**YUCCA MOUNTAIN PROJECT**

**A CONSENSUS PEER REVIEW OF PREDICTIONS OF SEEPAGE INTO  
THE DRIFTS OF A PROPOSED REPOSITORY AT YUCCA MOUNTAIN**

Figure 4.1

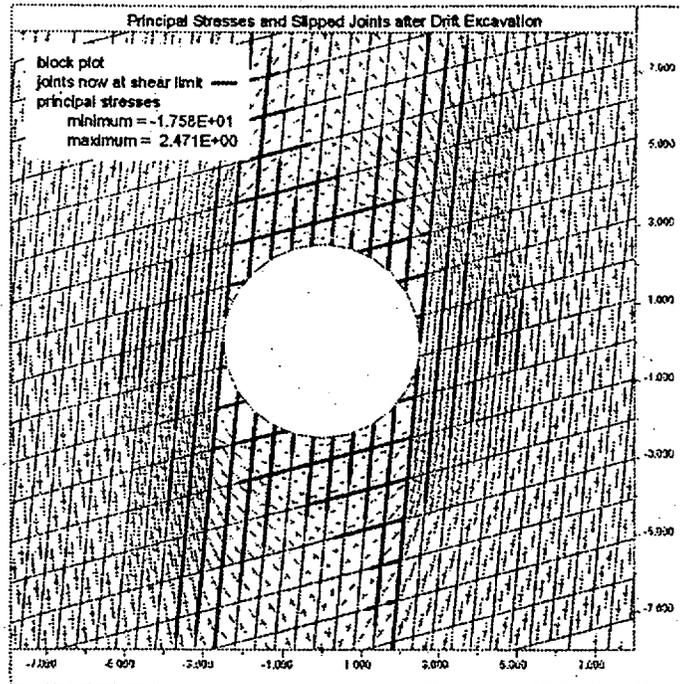
Figure 4.1 (from Fairhurst 1999) illustrates potential slip planes along subvertical fractures after excavation and before thermal heating. Figure 4.2 (from Chen 1999) illustrates a potential configuration of blocks around a drift after a seismic event but before heating. In either illustration it is not difficult to conceive how the capillary barrier to drift seepage surrounding the drift has been permanently affected. Repository heating tends to close fractures and reduce the impact of seismic events. These illustrations are included here to demonstrate that although modeling effort is underway by the YMP to assess roof stability for engineering a repository at Yucca Mountain, it appears none of the modeling has been directed at understanding the implications of geomechanical responses to predicting moisture seepage into the repository drifts.

Figure A.4.1

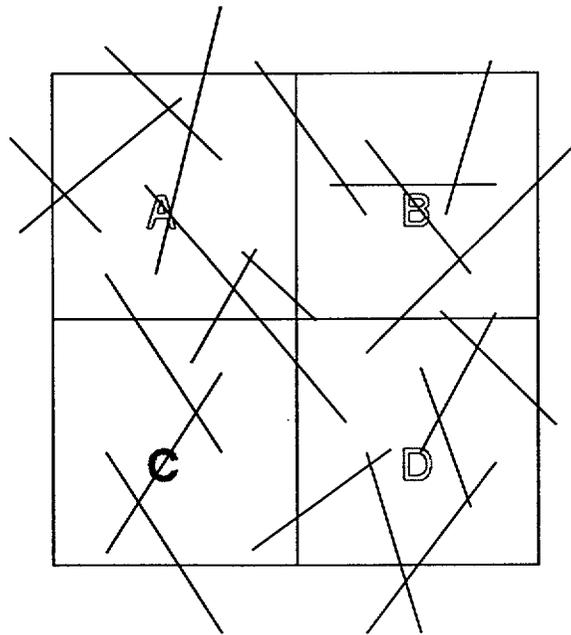
Figure A.4.1 shows a hypothetical fracture pattern and some 2D square elements. The goal of effective properties is to calculate values for flow parameters, such as permeability, for each grid cell that enables the grid cell to mimic the flow effects of the fracture network (and the rock matrix if the matrix is permeable). The diagram shows that all four squares have continuous fracture pathways from the bottom of the cell to the top. Likewise, cells A and B have continuous fracture paths from left to right. In order to correctly represent the permeability of each of these cells, all four would require some component of fracture permeability in the up-down direction, and cells A and B would require fracture permeability in the left-right direction. This would make it possible for moisture to flow from the top of the model to the bottom or from the left edge to the right.

Figure A.4.2

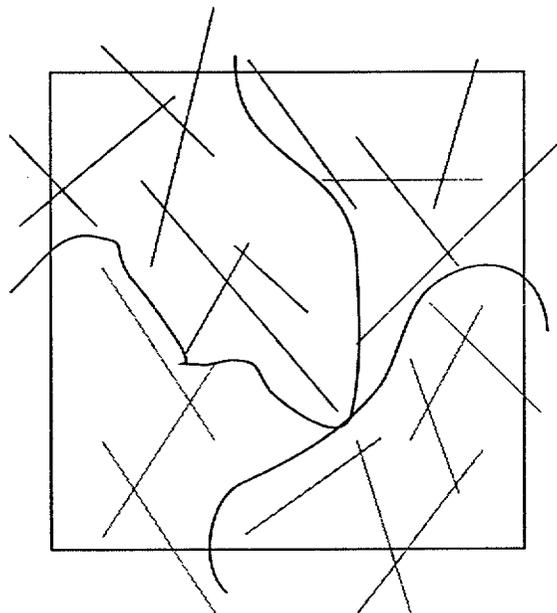
However, when moisture flow is considered on a larger scale, we find that this representation is not correct and could lead to erroneous results. Consider the same diagram, but now as a single larger grid cell (Figure A.4.2).

Figure A.4.2 shows that in fact there is no continuous fracture pathway connecting the top of the model to the bottom, or the left side of the model to the right. Rather, the fracture network is compartmentalized, as shown by the lines we have added to the diagram to separate the fractures into separate clusters. If moisture were introduced to the top of the model, it would not percolate via fracture pathways to the bottom of the model. However, an effective parameter calculation would suggest that continuous percolation would occur, when in fact it could not. Work at the Kamaishi mine in Japan has demonstrated that this type of fracture network compartmentalization occurs at the drift scale. Work in fractured oil reservoirs indicates that compartmentalization of the connectivity of fracture networks is common at larger scales as well.

Figure A.4.3

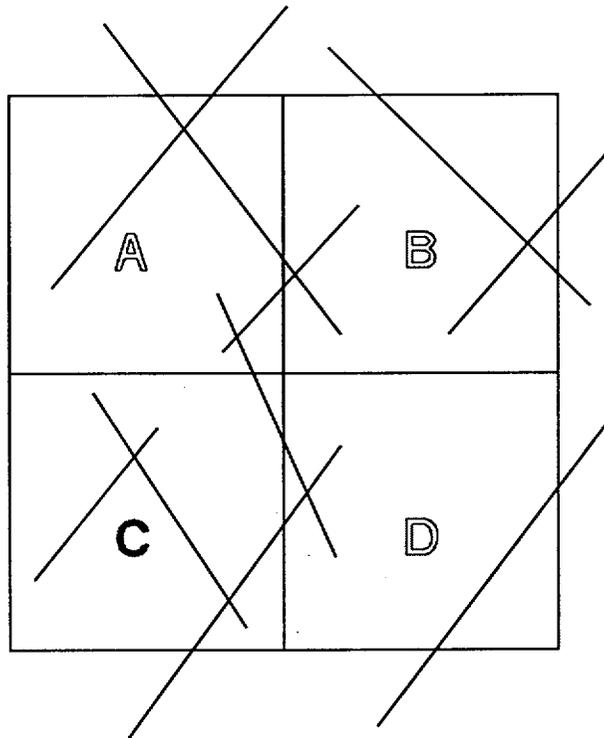
The opposite situation can also occur. Consider Figure A.4.3. Not one of the four grid cells has a continuous pathway from top to bottom or from left to right that is completely contained within the grid cell. This would imply that the effective fracture network permeability in each grid cell is 0.0. However, there are continuous fracture pathways from top to bottom at a larger scale. In this instance, there would be percolation from the top of the model to the bottom through the fracture network, whereas an effective parameter calculation would indicate that there could be none.

Another interesting challenge in calculating effective parameter values for describing moisture percolation through fracture networks is shown in grid cell D of this example in Figure A.4.3.

Presumably, water could be introduced to the fracture on the right side of D and it would flow out the fracture at the bottom of D. To represent this as a tensor, one would have to have a non-zero value for the off-diagonal component, or  $K_{xy}$ . However, there is no component for  $K_{xx}$  or  $K_{yy}$ : they are 0.0. Moreover, as shown by studies of the electrical resistance of line patterns (La Pointe and Hudson 1985), the principal directions of resistance (or conductivity) are not necessarily orthogonal, nor are they limited to two directions even in 2D line patterns. Both these situations are very difficult to capture through a symmetric permeability tensor that underlies the effective permeability parameter approach.
